Model: OR-C2	Date: 28-Aug-13	No.: RD759001a
---------------------	-----------------	----------------

Subject: Firmware Release Note: Fax		Prepared by: T.Nihei	
From: 2nd Tech Service Sect., MFP/Printer Tech Service Dept.			
Classification:	<input type="checkbox"/> Troubleshooting <input type="checkbox"/> Mechanical <input type="checkbox"/> Paper path <input type="checkbox"/> Product Safety	<input type="checkbox"/> Part information <input type="checkbox"/> Electrical <input type="checkbox"/> Transmit/receive <input checked="" type="checkbox"/> Other (Firmware)	<input type="checkbox"/> Action required <input type="checkbox"/> Service manual revision <input type="checkbox"/> Retrofit information <input checked="" type="checkbox"/> Tier 2

Model:OR-C2 Fax		Date: 24-Oct-13	No.: RD759002
Subject: Service Manual Correction for Installing the Double G3 Boards (TWN only)		Prepared by: T. Nihei	
From: 2nd Tech Service Sect., MFP/P Tech Service Dept.			
Classification:	<input type="checkbox"/> Troubleshooting <input type="checkbox"/> Mechanical <input type="checkbox"/> Paper path <input type="checkbox"/> Product Safety	<input type="checkbox"/> Part information <input type="checkbox"/> Electr

- G3 Interface Unit (D759)
- Installing Double G3 Boards

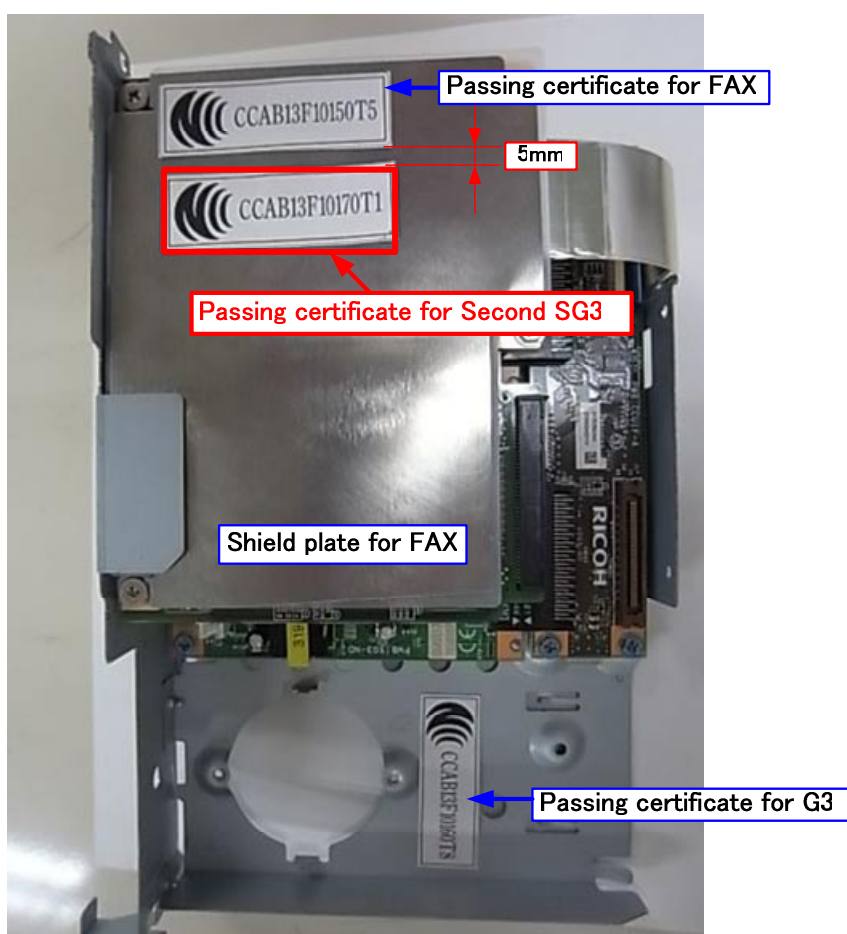
Add the following as **Step 6** to the Installation Procedure.

6. [TWN model only]:

Attach the decal packaged with the G3 Interface Unit to the area shown in red below.

1. FAX Option (D759)

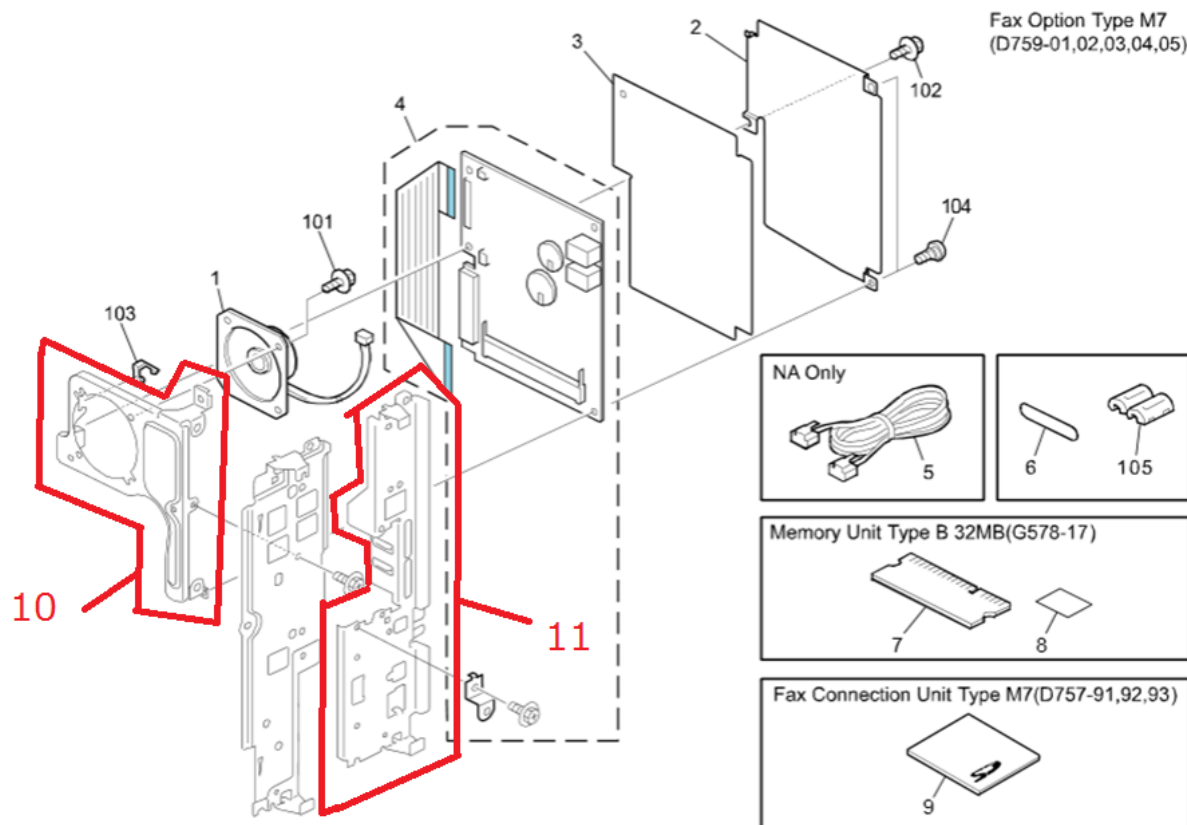
Change: The parts boxed in red in the illustration were registered as service parts.

Reason: To meet requests from the field.
